SERVICE BULLETIN SB00.12

Machines/Models:MX15/19

PURPOSE: Eliminate the possibility of water ingress into the motor controller

Figure 1

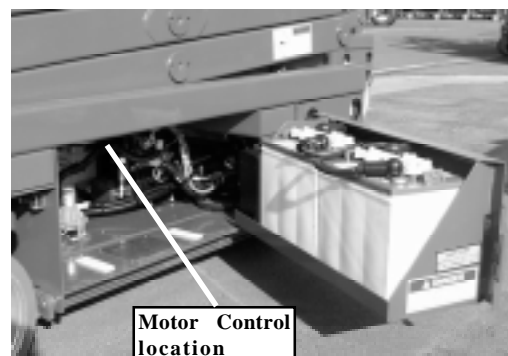
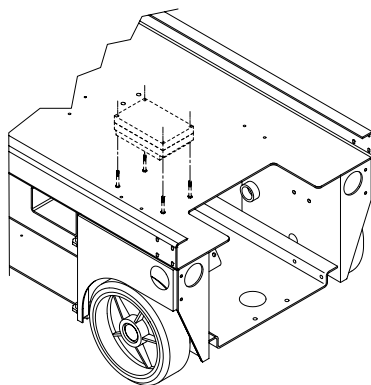
PROCEDURE REQUIRED: Replace the motor controller

KIT INCLUDES: 1 each - 065708-001 motor controller

1. Open the Chassis doors to gain access to the motor controller and batteries (see Figure 1).
2. Remove the battery negative cable from the batteries.
3. Label the wires and cables connected to the motor controller for reinstallation.
4. Remove all wires and cables to the Motor Controller.
5. Remove the motor controller and retain (this motor controller is to be returned to UpRight with the completed Warranty Claim Form).
6. Install the supplied motor controller, torque attachment bolts to 18 to 20 Ft. Lbs (25-27 Nm).
7. Attach and secure the wiring and cables per the labels installed in step #3.
8. Reattach the battery negative cable disconnected in step #2.
9. Perform the Pre-Operation and Safety inspection as instructed in the Operator Manual to ensure proper operation of machine.
